SERVICE BULLETIN – 01/NOVEMBER 2010

SPN 405-605 NEW WATER TUBE & FITTINGS

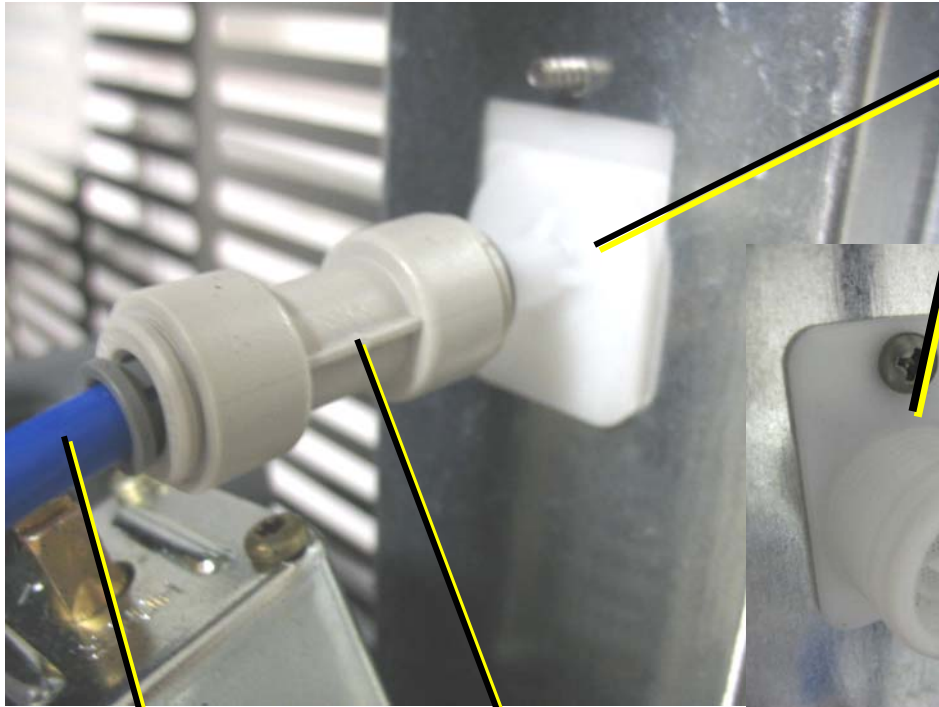
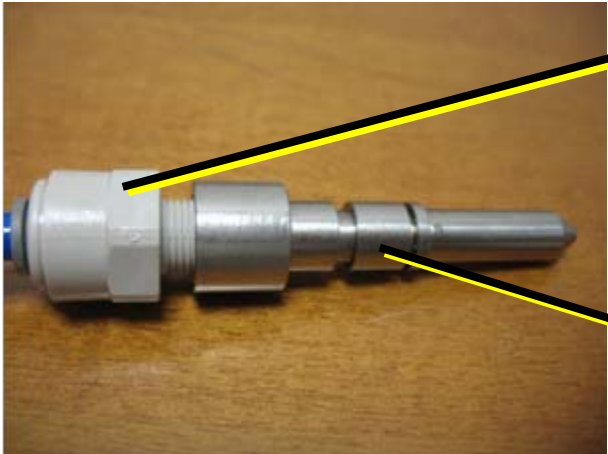
As done on past year with the Models SPN 125-255, the **entire water inlet /fittings** has been redesigned moving from copper tube to **John Guest** quick connections and nylon tube.

Cod.	Description
660956 00	Water inlet plastic fitting
651206 01	¼ male fitting
651206 02	¼ OD nylon tube (sold per meter)
651224 04	¼ female – 5/16” female connector
723107 02	¼ female S.S. nozzle
